# RB101-07/08

## R401.3

**Proponent:** Gary J. Ehrlich, National Association of Home Builders (NAHB)

**FIGURE R403.1(1)**  
**CONCRETE AND MASONRY FOUNDATION DETAILS**

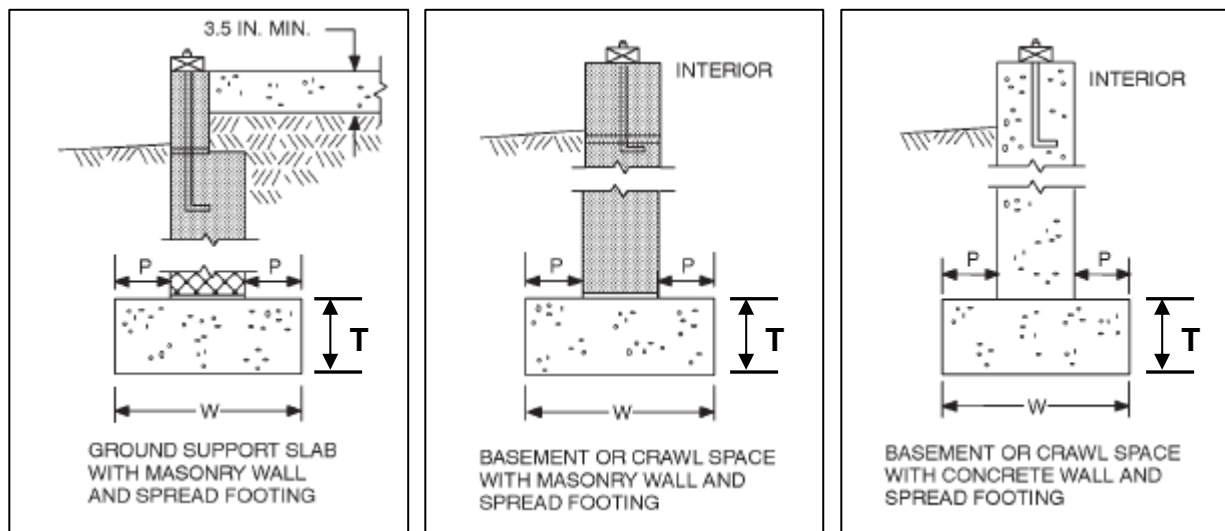
**Add "T", indicating footing thickness, to these spread footings (remainder of figure unchanged):**

**Reason:** The addition of the "T" detail to indicate footing thickness in the three footing drawings found in Figure R403.1(1) helps better represent and complement the information in R403.1.1 stating that projections shall not exceed the thickness of footings. This code identifies the relationship of WIDTH, PROJECTIONS, and THICKNESS of the footing and the addition will help illustrate this.

**FIGURE R403.3(1)**  
**INSULATION PLACEMENT FOR FROST-PROTECTED FOOTINGS IN HEATED BUILDINGS**

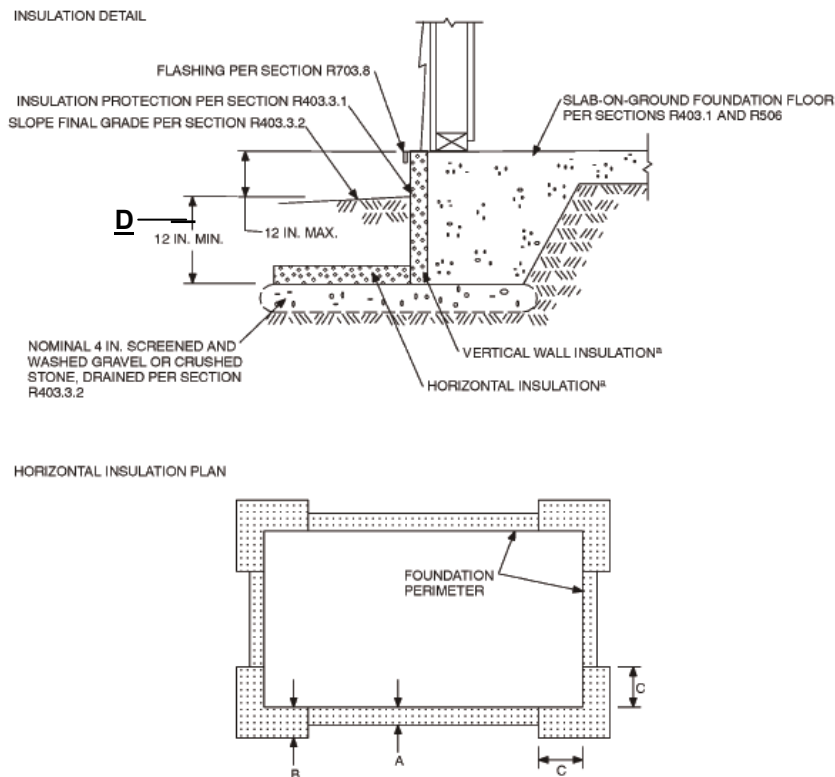
**Reason:** Section R403.3 of the code contains prescriptive provisions to protect footings from frost heave. Those provisions are just one of the alternatives to meet the minimum footing depth requirements in Section R403.1.4. ASCE 32, *Design and Construction of Frost-Protected Shallow Foundations* is also referenced as another alternative for frost protection of the footings (See R403.1.4.1). As the air freezing index increases however Table 4 in ASCE 32 requires deeper footing depths for heated buildings than those prescribed by the requirements in Section R403.3 and Table R403.3. The provisions in Section R403.3 are based on the same technical data used to develop the requirements in ASCE 32. This change revises Table R403.3 and related Figure R403.3 to be consistent with the minimum footing depths required for heated buildings in ASCE 32 based on the air freezing index.

**FIGURE R505.1.2**  
**IN-LINE FRAMING**

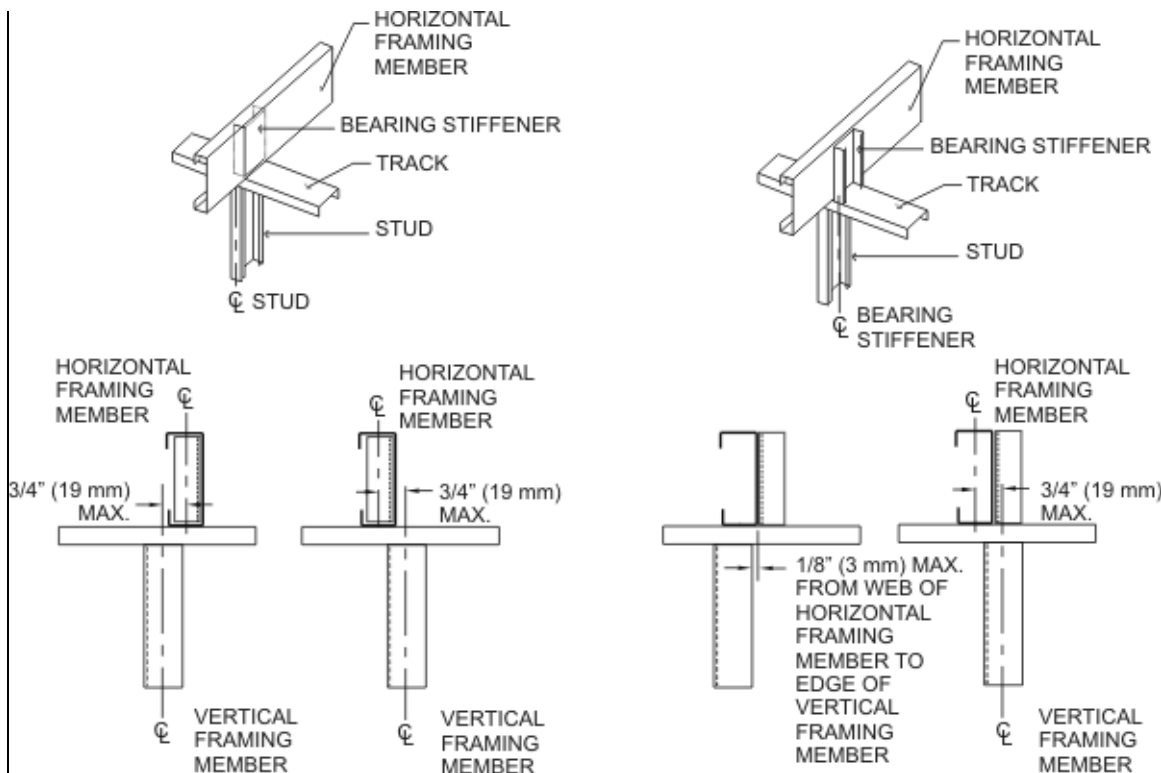
15. Add new figure as follows:

**Section R505.1.2:** The 2007 edition of AISI S230 references the 2007 edition of AISI S200 (*North American Standard for Cold-Formed Steel Framing—General Provisions*) which has revised the in-line framing tolerance to account for the special case of the bearing stiffener located on the back-side of the joist. This was based on research at the University of Waterloo (Reference: Fox, S.R. (2003), "The Strength of Stiffened CFS Floor Joist Assemblies with Offset Loading," American Iron and Steel Institute, Washington, D.C.)

**FIGURE R505.2.5.3  
WEB HOLE PATCH**

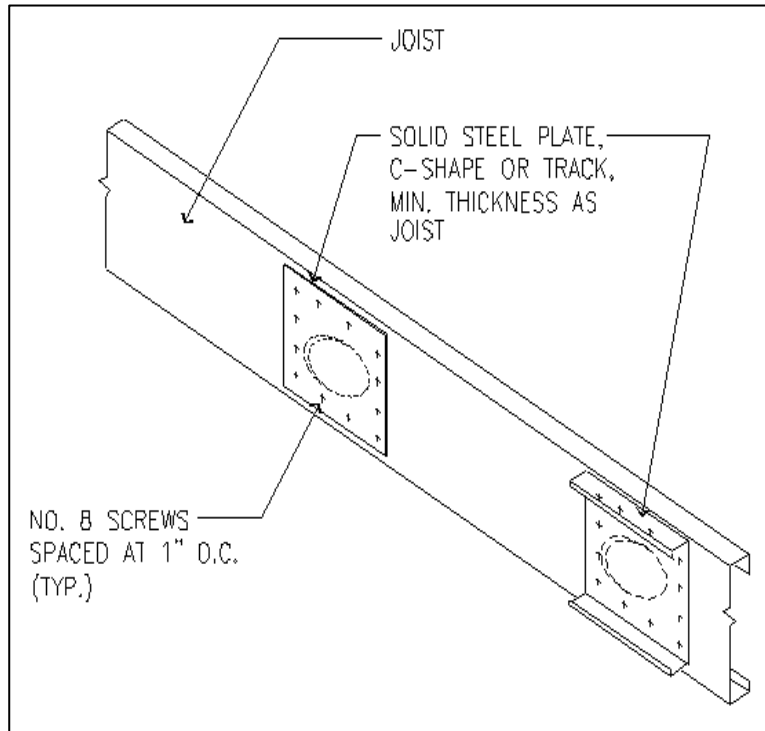
17. Add new figure as follows:

**Section R505.2.5.3:** This language has been relocated from Section R505.3.6 in order to improve the clarity and usability of the code. Modifications have been made to the charging language to reflect the fact that the user now has the choice to reinforce non-conforming holes, patch non-conforming holes, or design non-conforming holes with accepted engineering practice per Section R505.2.5.1. Additionally, Figure R505.2.5.3 has been added as an update to the old Figure R505.3.6, in order to coordinate with AISI S230-07.

**Section R505.3.6(old):** This section has been relocated to a new Section R505.2.5 on web holes, web hole reinforcement, and web hole patching. Figure R505.3.6 is outdated and has been substituted with a new Figure R505.2.5.3, which coordinates with AISI S230-07.

**FIGURE R505.3.4(2)**  
**BEARING STIFFENER**

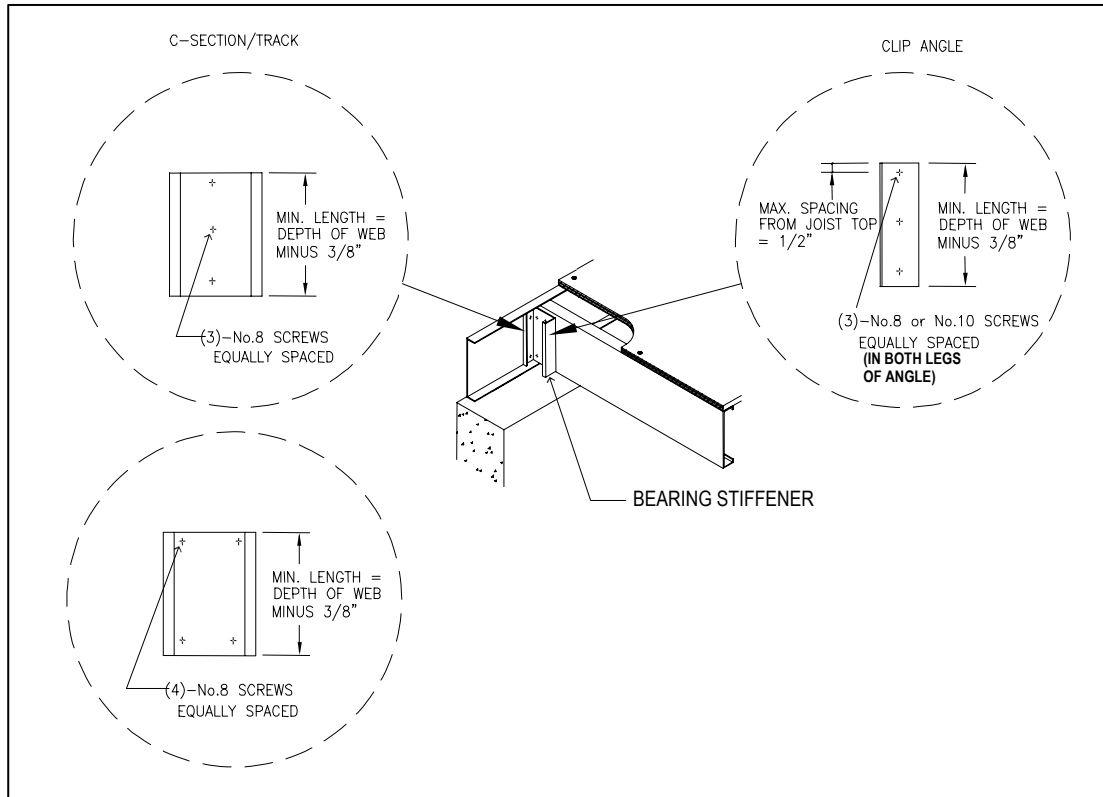
21. Delete existing Figure R505.3.4(2) and replace as follows:

**Section R505.3.4, Tables R505.3.4(a)-(d), and Figure R505.3.4:** This section has been updated to coordinate with AISI S230-07. The 2007 edition offers more options with respect to bearing stiffeners and this section has been expanded accordingly. Four tables were added detailing the design of clip angle bearing stiffeners in order to permit more options for the builder in the field. Additionally, Figures R505.3.4(1) and R505.3.4(2) were added to reflect these new options.

**FIGURE R505.3.78**  
**TRACK SPLICE**

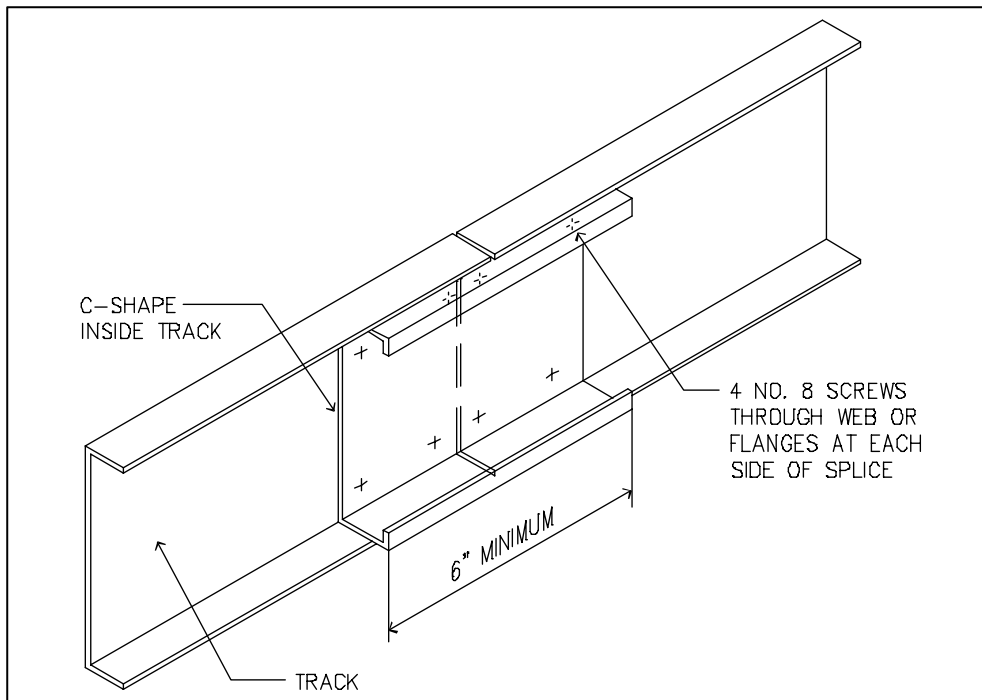
23. Delete existing Figure R505.3.8, renumber and replace as follows:

**Figure R505.3.8(old):** This figure has been updated to coordinate with AISI S230-07.

**FIGURE R602.10.1.32 (Supp)**  
**ANGLED CORNERS**

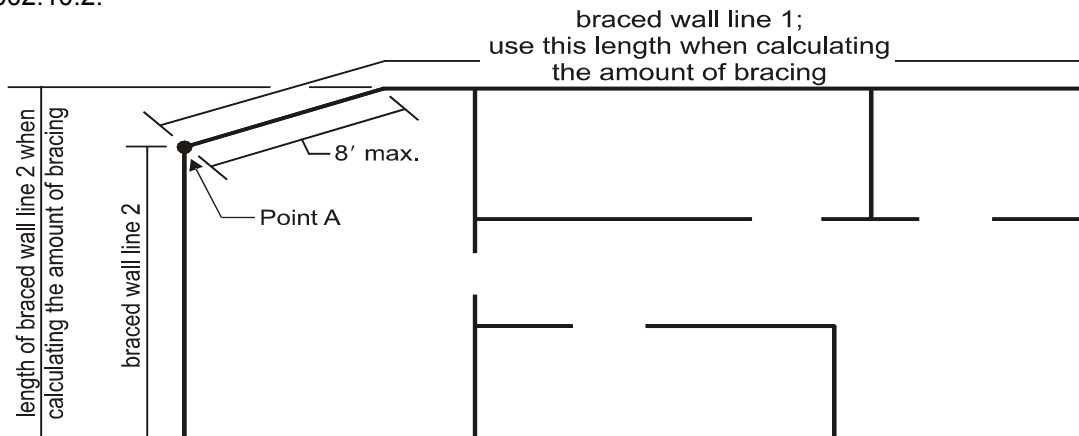
**R602.10.1.23 (Supp) Angled corners.** At corners, braced wall lines shall be permitted to angle out of plane up to 45 degrees with a maximum diagonal length of 8 feet (2438 mm). When determining the percentage of bracing, the length of each braced wall line shall be determined as shown in Figure R602.10.1.3. The placement of bracing for the braced wall lines shall begin at the point where the braced wall line, which contains the angled wall adjoins the adjacent braced wall line (Point A as shown in Figure R602.10.1.3). Where an angled corner is constructed at an angle equal to 45 degrees and the diagonal length is no more than 8 feet (2438 mm) in length, the angled wall may be considered as part of either of the adjoining braced wall lines, but not both. Where the diagonal length is greater than 8 feet (2438 mm), it shall be considered its own braced wall line and be braced in accordance with Section R602.10.1 and methods in Section R602.10.2.

**FIGURE R602.10.1.34.1 (Supp)**  
**BRACED WALL PANELS AT BRACED WALL-LINE ENDS IN SEISMIC DESIGN CATEGORIES D<sub>0</sub>, D<sub>1</sub> AND D<sub>2</sub>**

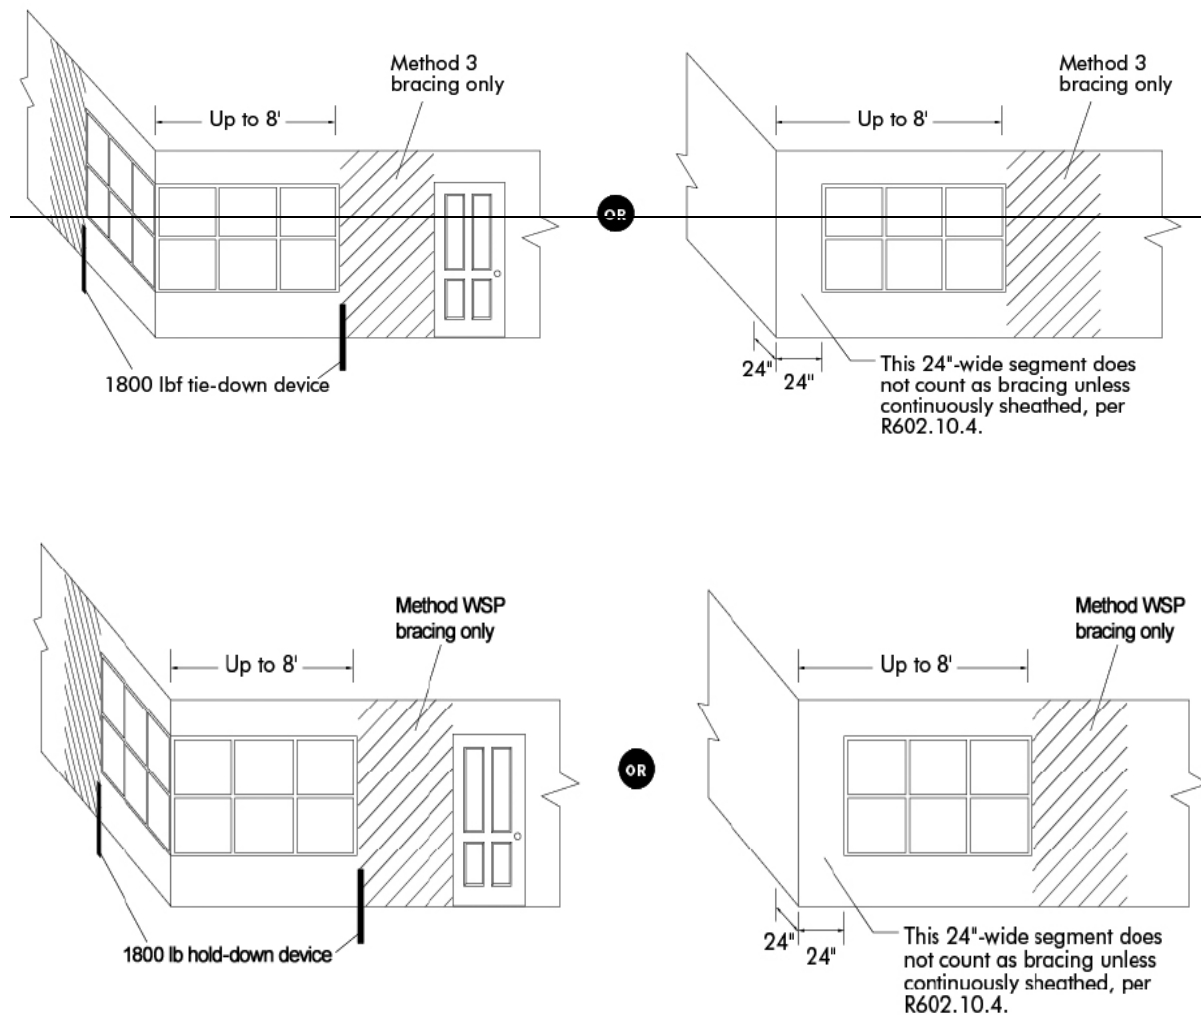
**2. Delete and substitute as follows:**
